Barratt David Wilson Homes & Hopkins Homes Ltd

Humber Doucy Lane, Ipswich Flood Risk & Drainage Proof of Evidence

Inspectorate reference: APP/X3540/W/24/3350673

DECEMBER 2024

Figure 1 – Extract from RSK drawing 0003.

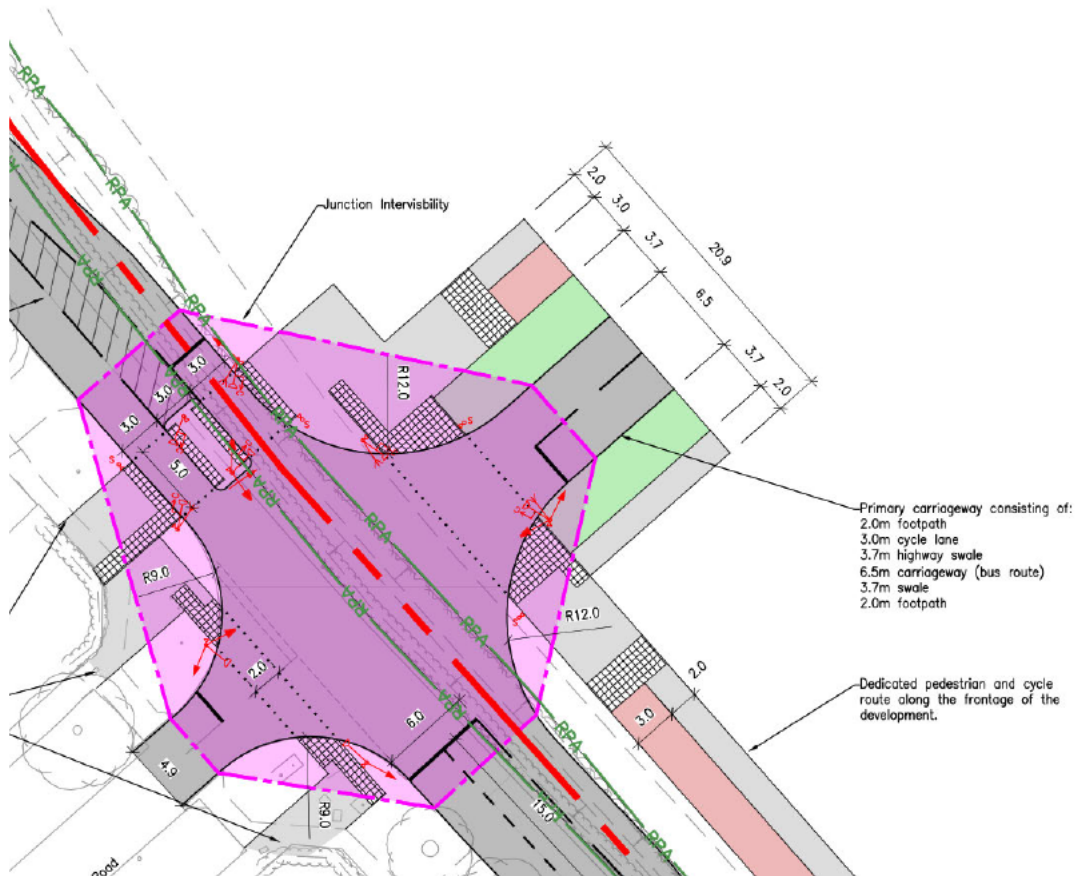
In accordance with the Suffolk SuDS Guide and Suffolk Design for Streets Guide the main access roads should be drained to roadside swales. Cross sections should be provided to demonstrate how space has been provided to ensure this can be accommodated in the final layout.

- 6.9 The main road (*Spine Road*) was designed in accordance with the Suffolk SuDS Guide and Suffolk Design for Streets Guide in which they require main access roads to be drained to roadside swales.
- 6.10 Page 84 of PRP's Design and Access Statement illustrates the proposed cross section of the main road in 'Illustrative Option 1' and 'Illustrative Option 2'. Both images clearly demonstrate the spine round bound by two swales on either side of the road that will function as a key component of the highway drainage system.
- 6.11 RSK drawing 890695-RSK-ZZ-XX-DR-C-0003, which covers the proposed access strategy, defines the layout of the spine road. The note shown in the image below states that 3.7m is to be provided either side of the carriageway for swales.

6.18 It is also my opinion that the swales are clearly defined in PRP's Design and access statement and RSK drawing 0003 and is sufficient evidence to alleviate the concerns raised in SCC's objection number 7.

- 8.3 PRP's Design and Access Statement and RSK drawing 0003 clearly demonstrate the intention to include roadside swales and that the road corridor has been sized appropriately to accommodate roadside swales on either side.

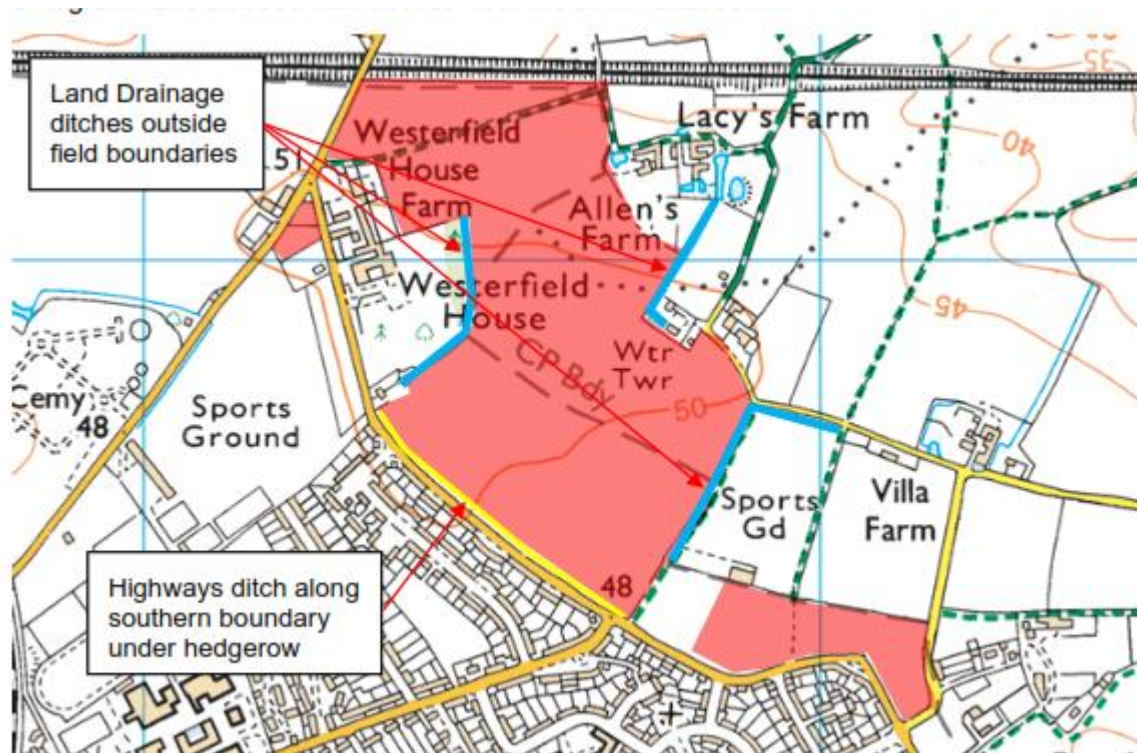
- 1. A plan of the watercourse network is included in the flood risk assessment and drainage strategy however it is missing some of the watercourses within and/or adjacent to the site. It is of vital importance that the development does not adversely impact the existing surface water network and thus a detailed survey of the existing watercourse network should be undertaken. This should comprise a walkover of the watercourse network and trace each from where it approaches the site, its connectivity through or around it to its outfall beyond the site's boundaries including any culverted sections. The plan should be updated and photos included where necessary. Any required maintenance to the network needs to be highlighted to ensure that the new development will not increase offsite flood risk.***

The image below, taken from the FRA, shows the ditches in the area as identified by OS mapping.

The OS mapping, IDB mapping and EA mapping do not indicate any further 'watercourse' features bounding the site. The western ditch, and southern ditch (along Humber Doucy Lane) and covered by the existing topographical survey and fall towards the southeastern corner of the development where they appear to terminate. No survey or OS line work indicates any other features in the vicinity. This would suggest that these features do not positively outfall and cannot be considered 'watercourses'. A preliminary site walk over has been conducted and did not indicate any connectivity between the features and/or a positive outfall.

Nevertheless, none of the development proposals include any material changes to these features, they are to be left in place and untouched allowing them to function as they were previously.
